Docket Number:	17-BSTD-02
Project Title:	2019 Title 24, Part 6, Building Energy Efficiency Standards Rulemaking
TN #:	222625
Document Title:	Public Health England Comments Simpler alternative to NEMA 77 to implement IEEE 1789-2015 closely
Description:	N/A
Filer:	System
Organization:	Public Health England/Luke Price
Submitter Role:	Public Agency
Submission Date:	2/21/2018 5:57:48 AM
Docketed Date:	2/21/2018

Simpler alternative to NEMA 77 to implement IEEE 1789-2015 closely

Figure 1: Comparison of TLA measures and conventional light sources.

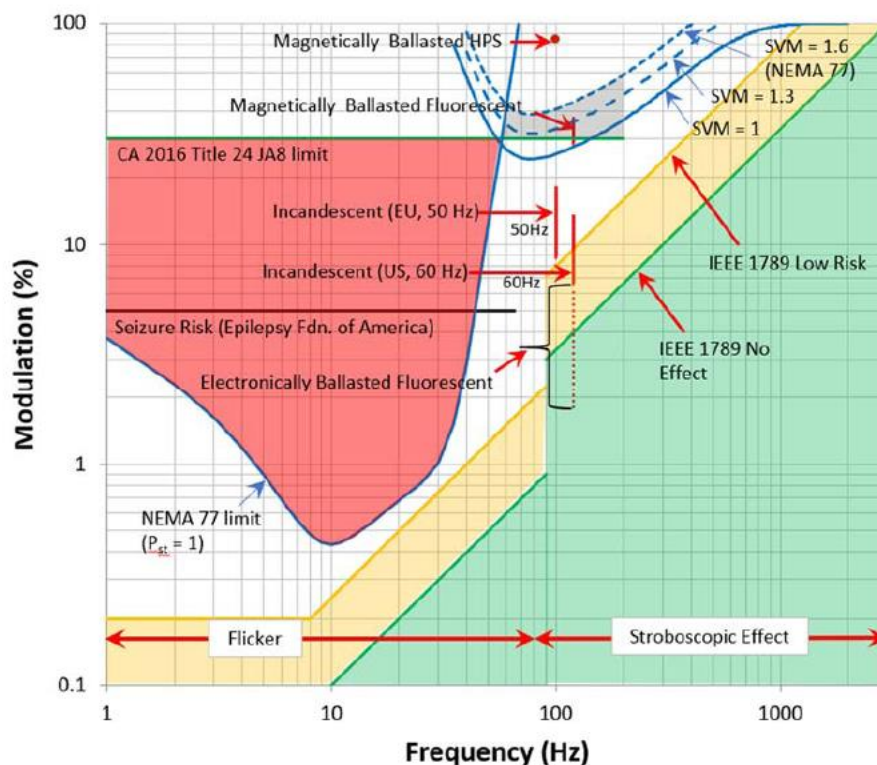
However, we do not agree with her response that setting the SVM threshold to 1 would be sufficient. (Docket Number: 17-BSTD-02, TN# 222548) provides a reproduction of the IEEE figure for categorizing flicker by percent modulation and frequency (copied as Figure 1). This is a log-log chart, and points that appear as comparable in magnitude are in fact only comparable in order of magnitude:

- At 60 Hz, 0.6% modulation or greater may produce an effect, whereas NEMA 77 proposes a threshold of over 30%. These are clearly not comparable levels, and the NEMA 77 proposal is inadequate.
- At 120 Hz, 4% modulation or greater may produce an effect, whereas SVM thresholds of 1 and 1.6 relate to 28% and 45% modulation respectively (approximately). Again, there is no comparison, and both these SVM levels are clearly inadequate.

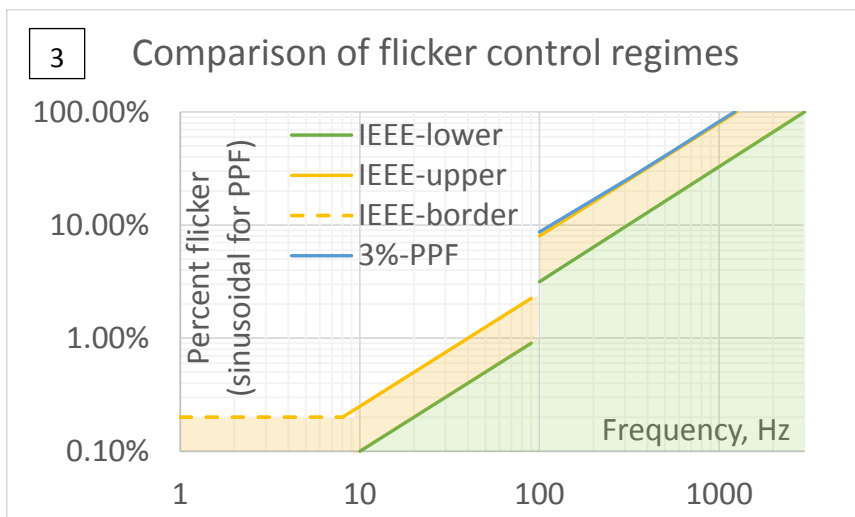
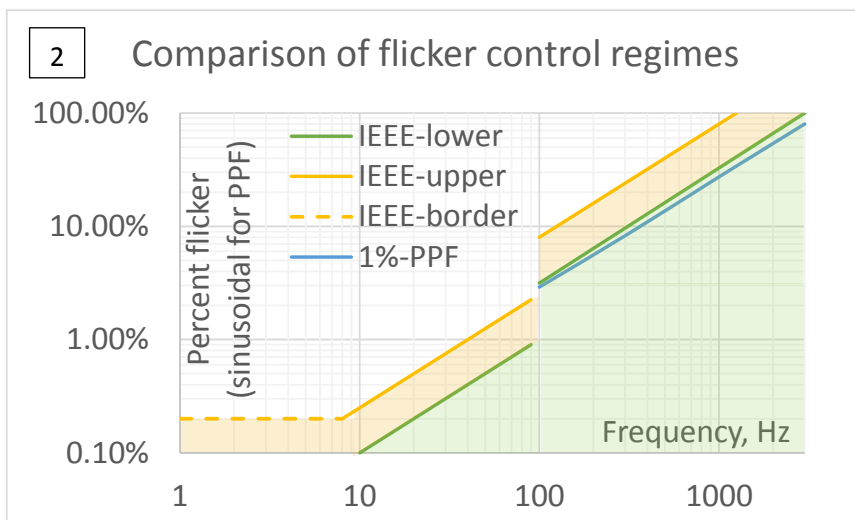
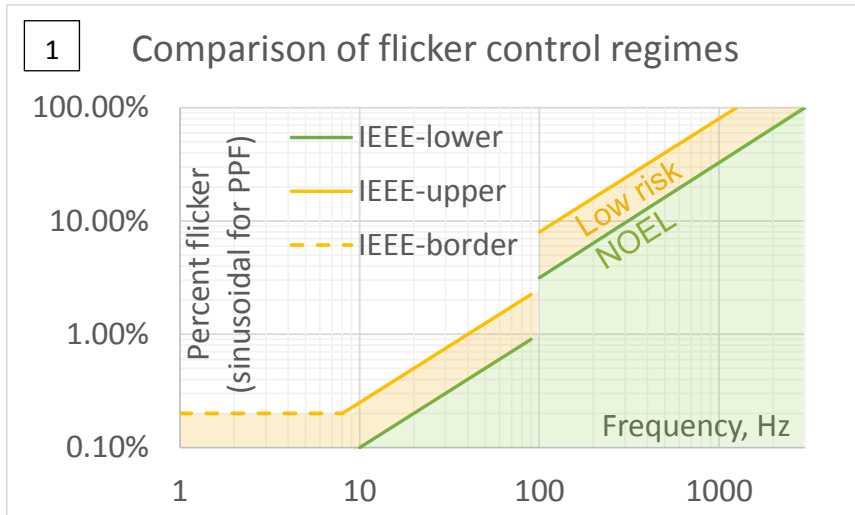
Some of the advocates of NEMA 77 are claiming it has an advantage in being able to implement IEEE 1789-2015 diagram more closely than previous standards, and allowing for the shape of the waveform. These would be important advantages if true, but as we have just set out the NEMA 77 option is not comparable to the IEEE 1789-2015 thresholds, and certainly not close to it at either 60 Hz or 120 Hz. Moreover, there is a simpler way to implement the IEEE 1789-2015 diagram closely; the PPF metric (Physiological Percent Flicker; Price, 2017) was developed from first principles to prevent light modulation producing any retinal response and closely reproduces the thresholds of IEEE. For all frequencies from 100 Hz and above, a PPF threshold of 1% will correspond closely with the IEEE 1789-2015 no observable effect threshold (3% will correspond closely with the IEEE 1789-2015 low risk threshold at these frequencies). See Figure 2 in the Annex containing our proposal.

In panels 2 and 3 of Figure 2, the blue lines have been added as part of the schema, and represent thresholds below which the Physiological Percent Flicker (PPF: Price, 2017) is lower than the percentage figures indicated. Please note these are not perfectly straight lines, and should not be extrapolated to lower frequencies.

Unlike the regime illustrated in the Flicker Report in panel 1 of Figure 2, the PPF calculation can be applied to non-sinusoidal waveforms, to predict the magnitude of response of the eye to general periodic flicker. The PPF metric achieves this by modelling the fastest photoreceptor responses in the eye as a simple exponential low pass filter, which mimics their delayed and smoothed response. Panels 2 and 3 show that their prediction in this frequency region are remarkably consistent with the consensus review of published data on the effects of flicker in Flicker Report.

- We recommend that adopting a PPF threshold of 1% will ensure all sources are categorised as having “No Observable Effect” according to the regime in the Flicker Report. This is our main proposal.

- A 3% PPF threshold would be sufficient to ensure that all sources are categorised as Low Risk, according to the regime in the Flicker Report. Whilst (Price, 2017) reports that this may eliminate the risk of health effects for a fixated observer in a static environment, it is important to recognize that the health effects associated with free observers in end-users environment where rapid eye movements known as saccades may be extremely important to predict the effects of periodic flicker and modulation on health. We believe that adopting a 3% PPF threshold would leave a significant risk of compliant products causing adverse health effects as well as other undesirable effects including Temporal Light Artefacts.
